Access Compliance Report Public Rights-of-Way (Curb Ramps)

Main Street: S_ESPLANADE_ST Cross Street: SPRING_ST Location: SW

ADA ID: RPRK211223115927 Ramp Type: Type 4 - Parallel Initial Pass/Fail: Fail Overall Compliance: No Severity Score: 2

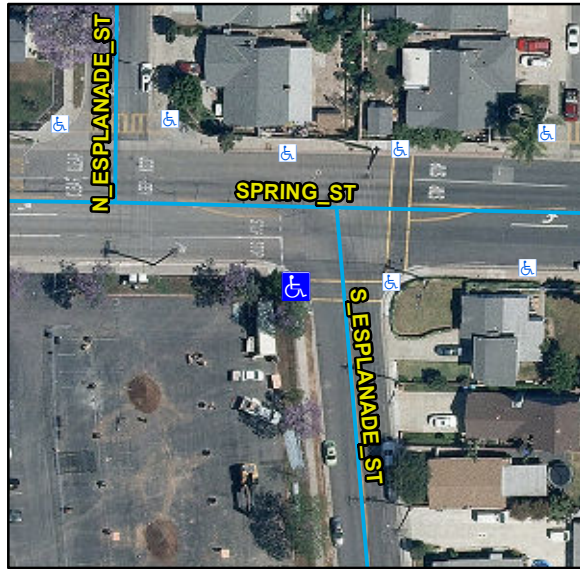
Compliance	Description	Data	Compliance	Description	Data
N/A	Ramp Length LT (in)	122	N/A	Ramp Length RT (in)	101
Yes	Ramp Width LT (in)	92	Yes	Ramp Width RT (in)	87
Yes	Ramp Run Slope LT (%)	6.1	Yes	Ramp Run Slope RT (%)	2
Yes	Ramp Cross Slope LT (%)	1.6	No	Ramp Cross Slope RT (%)	2.9
N/A	Landing Present	N/A	N/A	DWS Provided	N/A
N/A	Landing Length (in)	N/A	N/A	DWS Contrast	N/A
N/A	Landing Width (in)	N/A	N/A	DWS Length (in)	N/A
N/A	Landing Run Slope (%)	N/A	N/A	DWS Full Width	N/A
N/A	Landing Cross Slope (%)	N/A		DWS Offset Type	N/A
N/A	Landing Movement Obstructed?	N/A	N/A	DWS Offset Left (in)	N/A
	Landing Movement Type	N/A	N/A	DWS Offset Right (in)	N/A
N/A	Landing Shared	N/A			
N/A	Clear Space	Yes			
N/A	Clear Space To Crosswalk (in)	N/A			
N/A	Marked Crosswalk 1	Yes	N/A	Marked Crosswalk 2	No
	Crossing 1 Direction	E		Crossing 2 Direction	N
	Marked Crosswalk 1 Width (in)	120		Marked Crosswalk 2 Width (in)	N/A

Remove & Replace Curb Ramp With Two New Directional Ramps or Equivalent.

R304.5.3, STD 1115
